**AGENDA
CITY OF CREVE COEUR
PLANNING AND ZONING
300 NORTH NEW BALLAS RD
NOVEMBER 21, 2022
6:00 PM**

3. PUBLIC HEARING #22-027: Conditional Use Permit for A 9,044 Square Foot Mexican Barrel House Restaurant Located at 1085 North Mason Road

#22-032: AN AMENDMENT TO AN EXISTING CONDITIONAL USE PERMIT WITH ASSOCIATED SITE DEVELOPMENT PLAN FOR A NEW RESIDENCE HALL ON THE CHAMINADE COLLEGE PREPARATORY SCHOOL CAMPUS LOCATED AT 425 SOUTH LINDBERGH BOULEVARD

Figure 3: Colored south elevation of proposed Residence Hall.

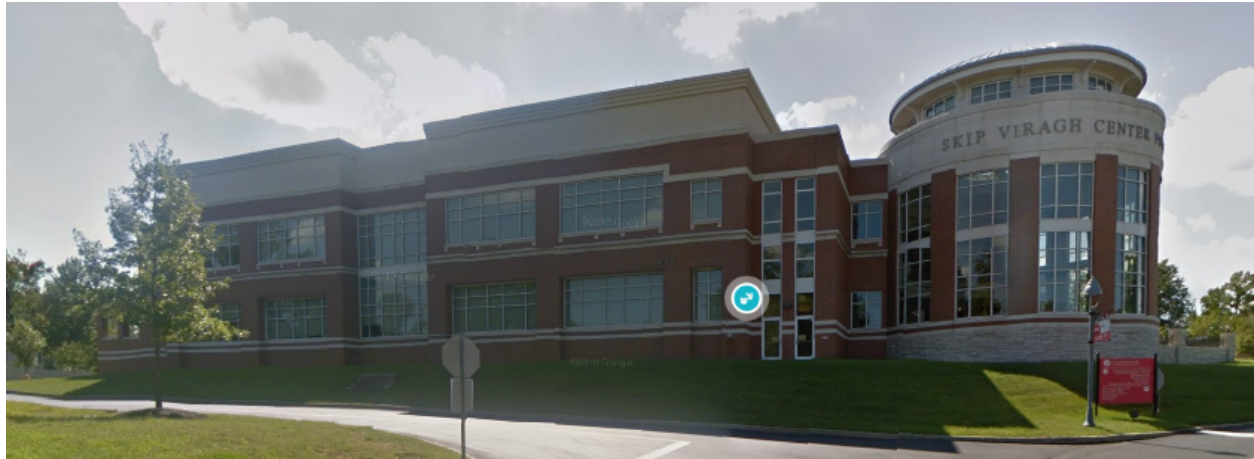
reduce the scale of larger buildings. (p.7). The proposed new building will feature a full masonry exterior with brick as the predominate material along with a cast stone base and stone trim to match the adjacent performing arts building. The overall design is traditional and appears to coordinate well with the materials of the adjacent performing arts building. Material samples will be available at the meeting for review.

The Design Guidelines state that Building elements, such as parapet walls, penthouses or screen walls should be treated as an integral part of the architecture, incorporating similar design, detail and materials as the primary structure. All rooftop equipment, including, but not limited to, satellite and other telecommunication equipment, air handling units, elevator equipment, cooling towers and exhaust fans are to be screened from view. Building screens should be part of the architectural design with similar detailing and materials and not appear as add-ons. The roof plan indicates that the mechanical equipment will be placed within a recessed area and screened. A condition has been included to require verification of the screening by staff as part of the permit review.

Figure 4: Close-up of the site plan showing the proposed sidewalk width of 5-feet,

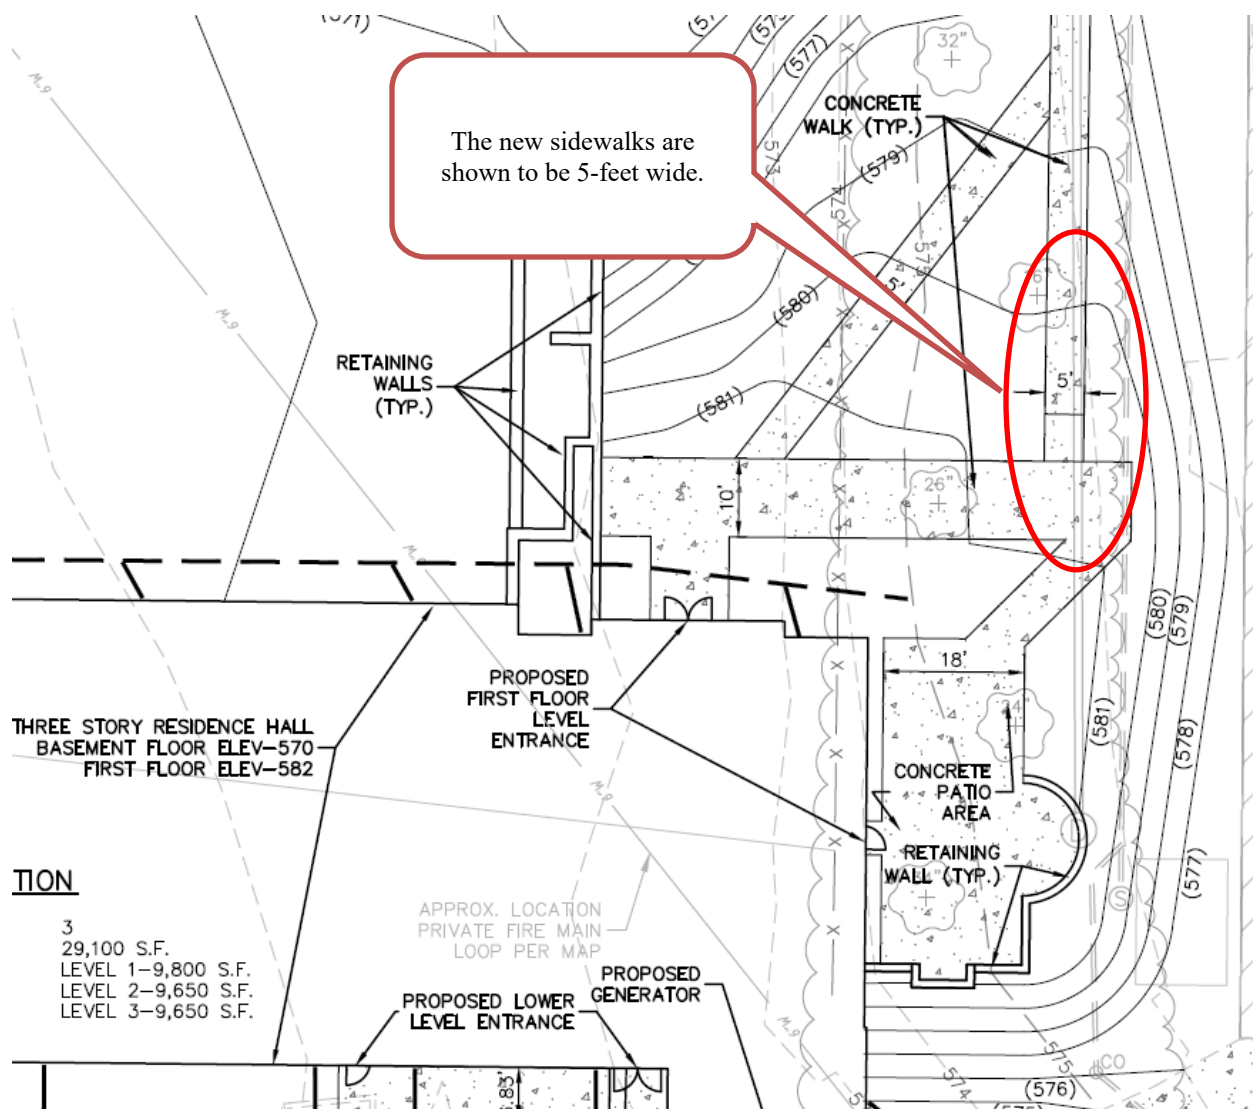
Section 405.730(A)(2) requires that the minimum width of internal sidewalks in non-residential developments shall be at least six (6) feet or eight (8) feet if used as a curb stop. The proposal includes sidewalks that are 5-feet in width. Staff has included a condition of approval that all new sidewalks should be a minimum of 6 feet in width.

6. All new internal sidewalks shall be a minimum of six (6) feet, or eight (8) feet if used as a curb stop per Section 405.730(A)(2).
7. All signs and banners shall be in conformance with Article VIII, Sign Regulations, of the Zoning Code, or with the approved Master Sign Plan for the Campus.

Figure 5: Landscape Plan

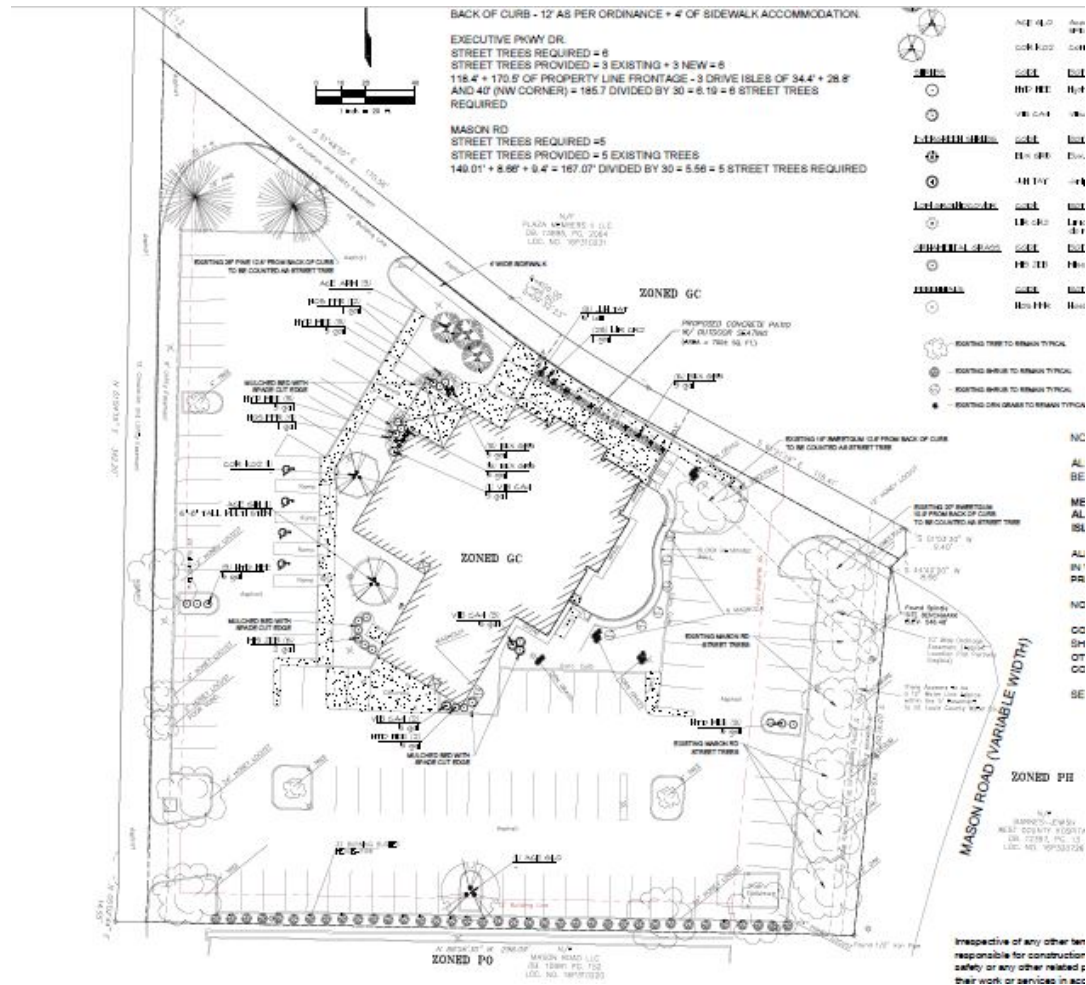
The landscaping for the site has been neglected and left in bad condition since the closure of the Houlihan's restaurant. Dead trees have already been cut down and the stumps will be completely removed to make room for new trees and landscaping around the main entrance. The existing street trees along Mason Road meet the requirement for the site and no new street trees are required. The applicant shows landscaping around the base of the new patio in order to soften its impact to the adjoining access road, new trees, shrubs and additional landscaping along the main entrance façade and additional landscaping throughout the site to give the site a more inviting atmosphere. Shrubs have been placed along the border with the adjoining property to the south in order to block headlight glare and trees have been placed in every landscaping island.

Figure 6: Applicant's Photometric Plan

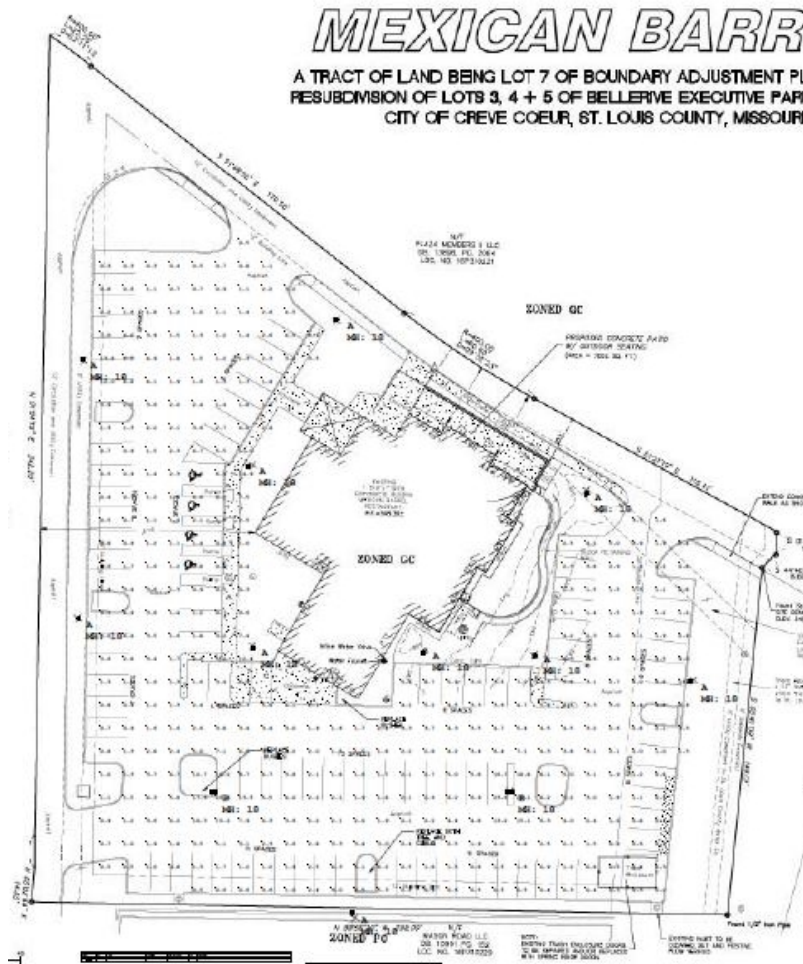
No new lighting is proposed for this location. Existing lighting on site needs repair and is non-compliant with Section 405.680. The applicant proposes to repair and re-use the existing building and site lighting. The existing lighting is not downcast or shielded and does spill light onto adjoining properties as shown in the submitted photometric plan. Staff recommends that the non-compliant light fixtures be replaced with downcast and shielded lighting that will not spill light onto adjoining properties. A condition of approval has been added to reflect that any new lighting meet the requirements for lighting in Section 405.680 and when the existing non-compliant lighting needs to be replaced that it be replaced with compliant utilities.
